**EQUUS BEDS GROUNDWATER MANAGEMENT DISTRICT  
BOARD OF DIRECTORS**  
**Aquifer Storage & Recovery (ASR) Proposed Permit Modifications**  
**April 19, 2018**

**APPLICANT: [City of Wichita](#)**

## Proposed modified Phase II approval

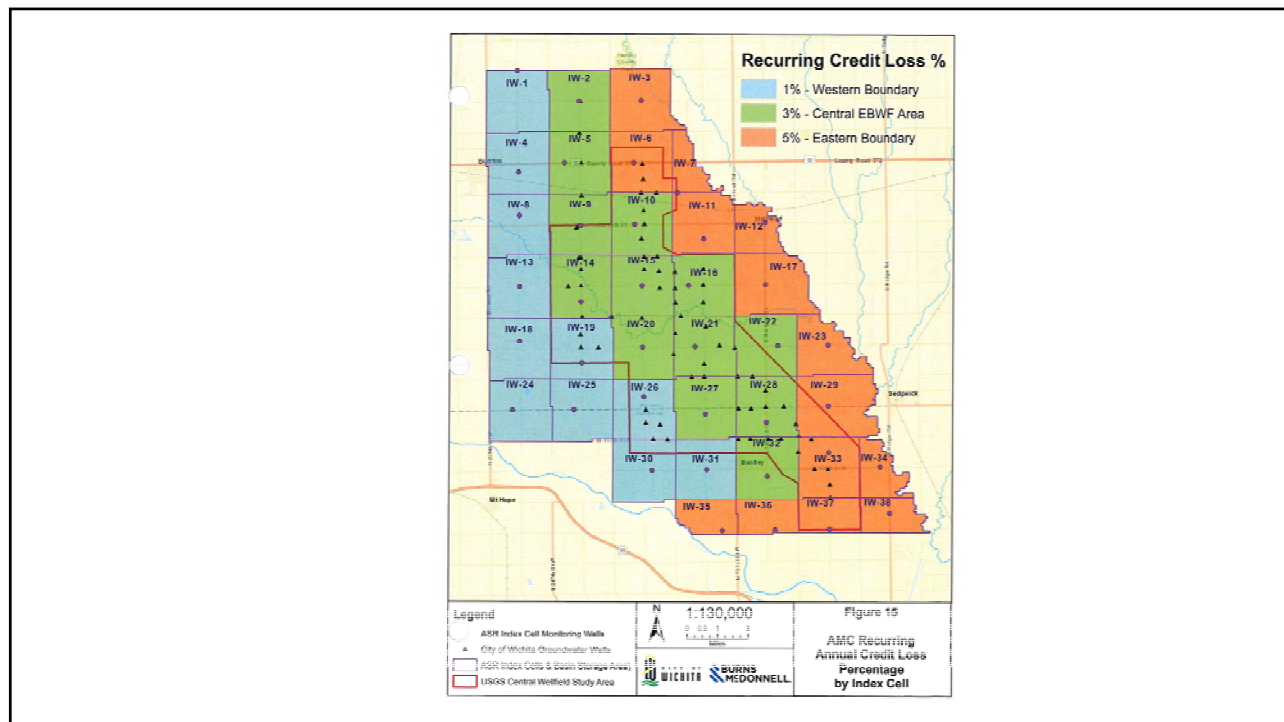
GMD2 Comment: Need more clarification / justification for 5% initial loss.
